Service Bulletin

No. : MZ05-022

Model: SA8260, SA-17S1

Subject: Cannot playback specific Super Audio CD Disc.

PV16-SERVO PWB

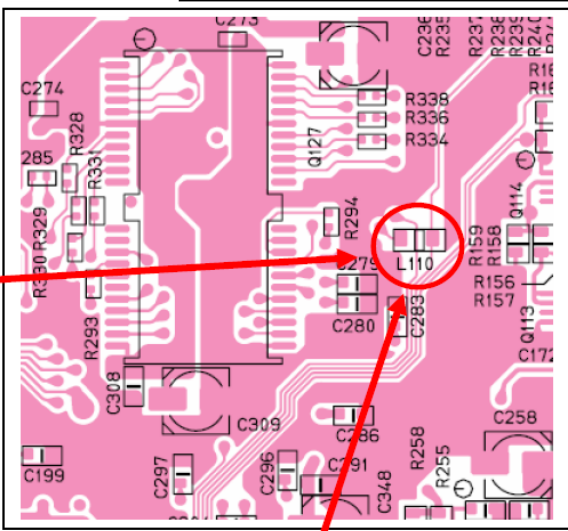
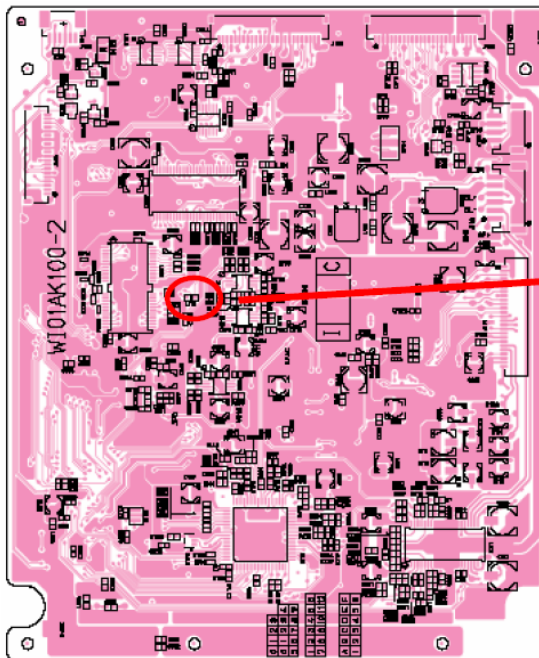
Solution: L110 Ferrite Core has been changed to a Chip Resistor (100 OHM)
on the PV16-SERVO PWB.

L110
